# STORMWATER MANAGEMENT PLAN

5575 SOUTH GIPPSLAND HIGHWAY, LANG LANG  
25/03/2022

PREPARED FOR AURORA CONSTRUCTION MATERIALS

### MELBOURNE WATER CORRESPONDENCE AND IN PRINCIPLE SUPPORT

WATERWAY TYPICAL SECTION - SECTION 1

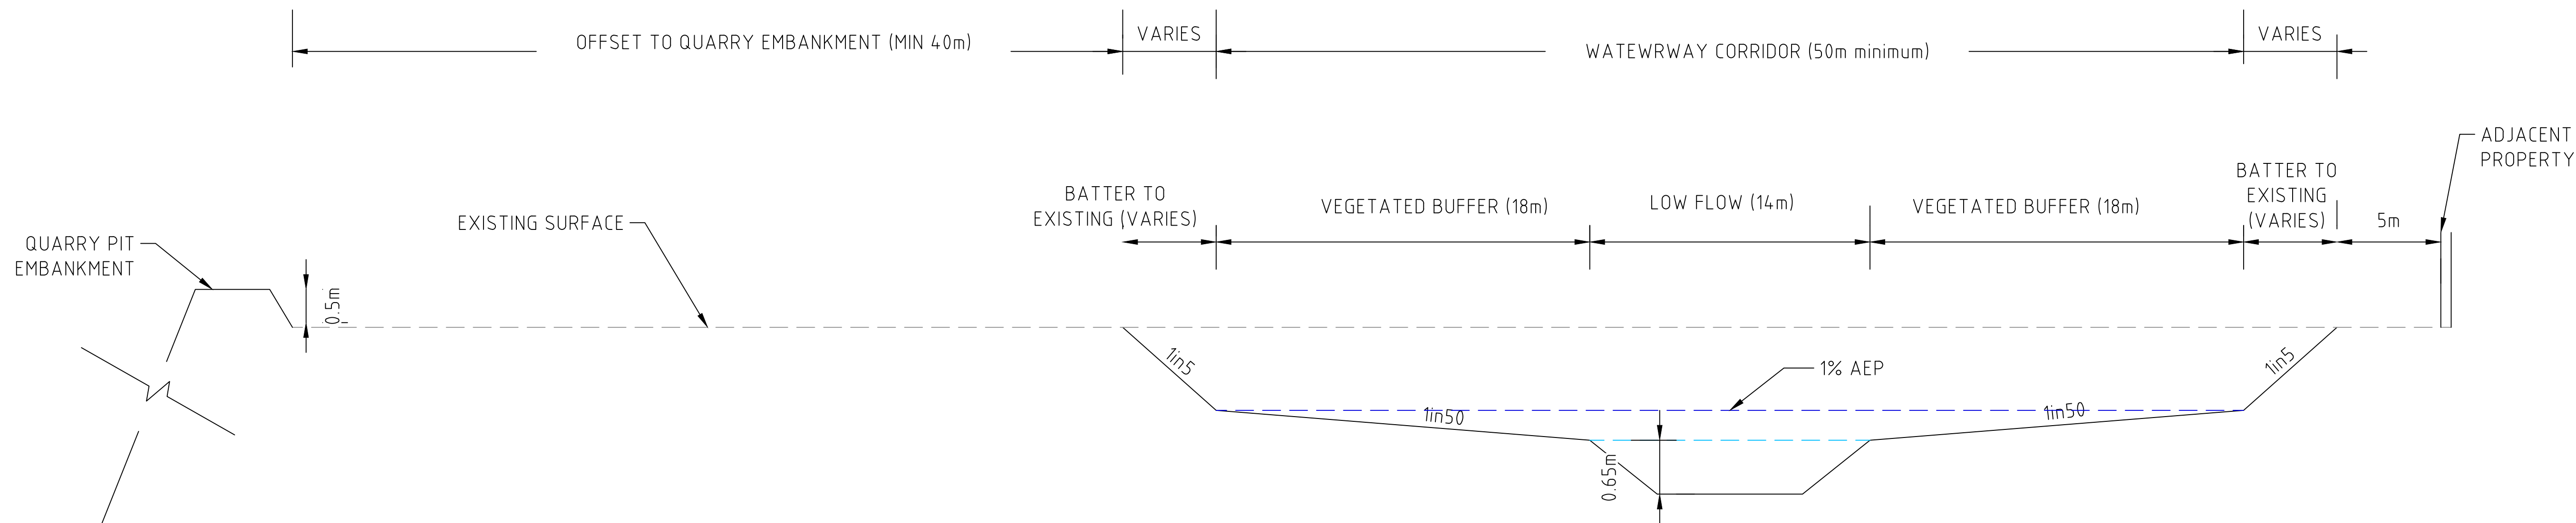
Section 1 appears to show some opportunities for geometry & sinuosity as outlined above.

The location of the Inflow is indicated as being within the quarry setback distance. How will this connect with the upstream waterway section and how will flows enter the diverted waterway? Similar questions with the downstream end & its connection with the downstream waterway.
